# **CX4 Transmit Jitter Spec**

**Dallas, TX  
Mar. 10-13, 2003**

**Presenter: Steve Dreyer, Intel**

# Jitter Specs: XAUI vs. CX4-WP3.1

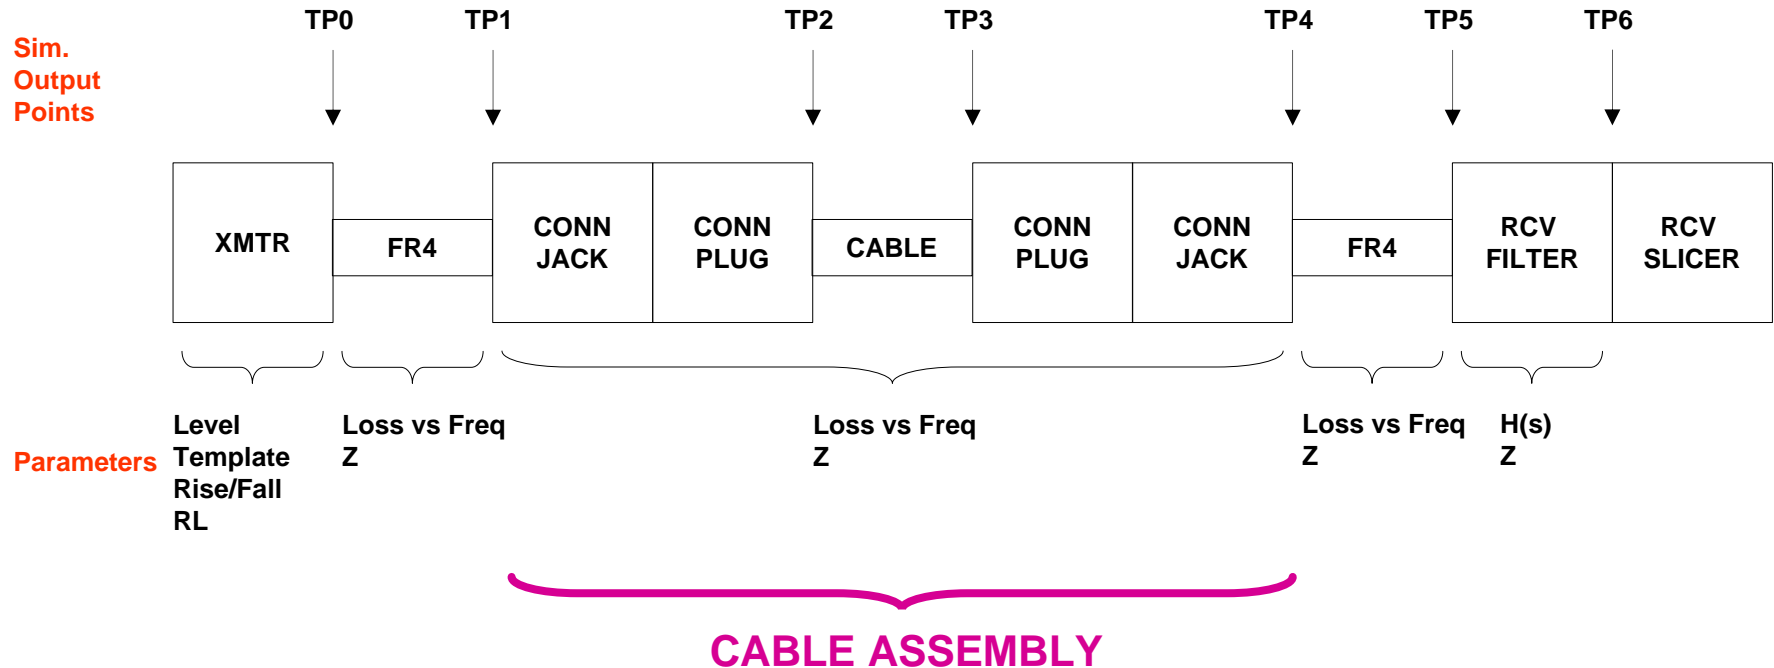
- Max RJ spec tightened in CX4-WP3.1 relative to XAUI
  - ◆ For CX4-WP3.1,  $RJ < 0.18 \text{ UI}$
  - ◆ For XAUI,  $0.18 < RJ < 0.35 \text{ UI}$ , depending on amount of DJ
  - ◆ Existing XAUI designs may not meet CX4-WP3.1 specs for RJ, even though that XAUI design may still meet total jitter limit
- Question:
  - ◆ Does changing the RJ jitter spec from XAUI to CX4-WP3.1 limits matter?

- Proposal:
  - ◆ Keep transmit jitter specs for CX4 same as XAUI (except spec at TP2)
